Cody Johnston, PE
Stonewall Structural Engineering, PLLC
4800 Falls of Neuse Rd. #120
Raleigh, NC 27609
(919)407-8663

Re: Structural Observation—24 West Landing, Sanford, NC 27332

BACK OFFICE WINDOW MODIFICATION

*Picture 1 – 24 West Landing,
Sanford, NC*

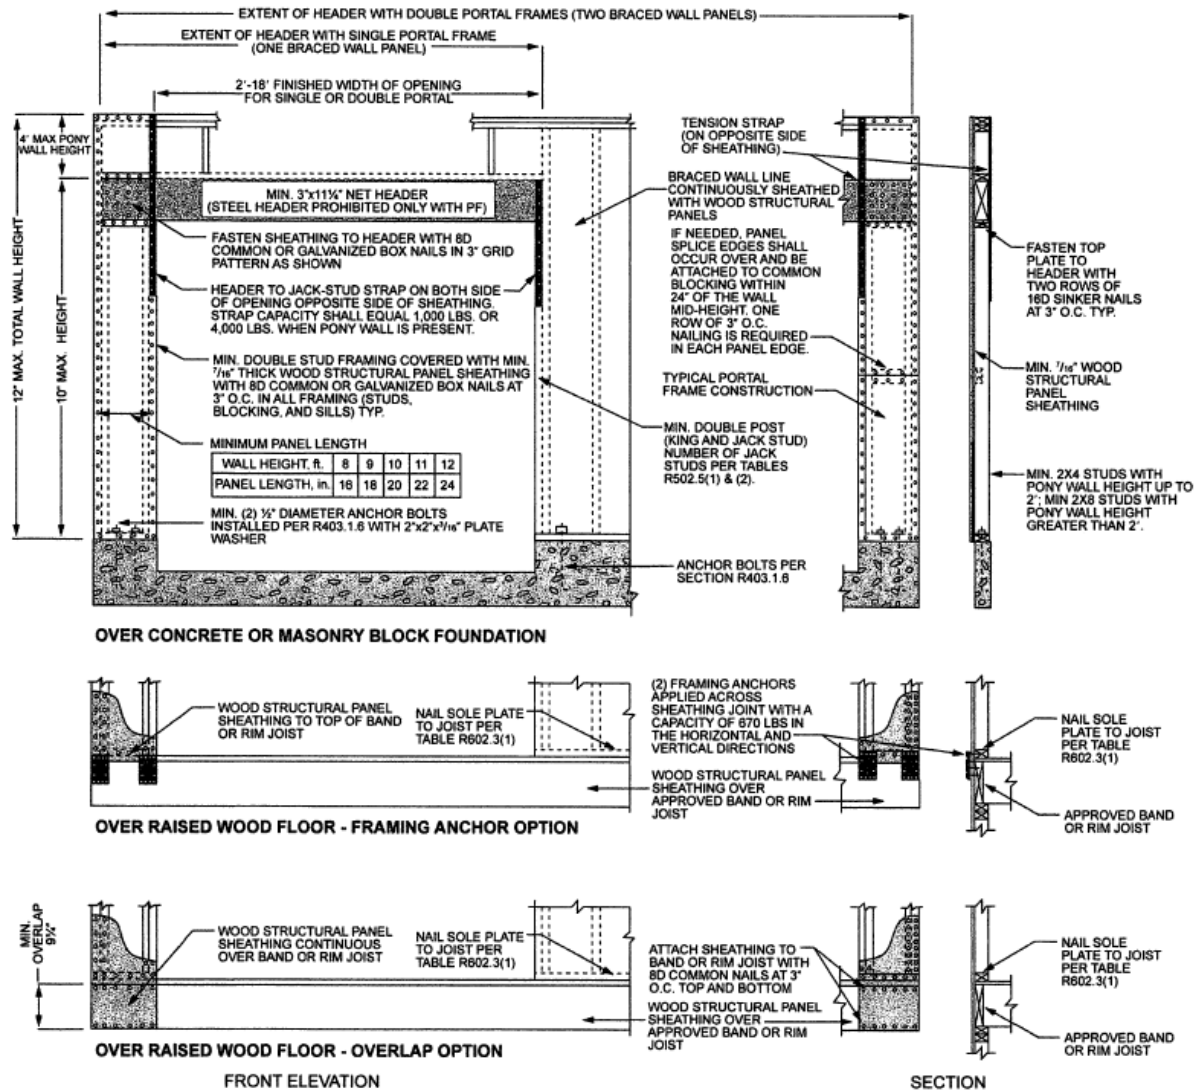
At your request, we analyzed the back office window opening that is proposed to be modified to accommodate a window and door combination at the Sanford residence noted above. Renovation drawings by Robert Mikesell dated 12/2/2005 were provided during a previous site visit. The structure is a conventionally framed, detached, single family residence with raised 1st floor framing over a pier/girder foundation system with perimeter masonry foundation walls (*see picture 1*).
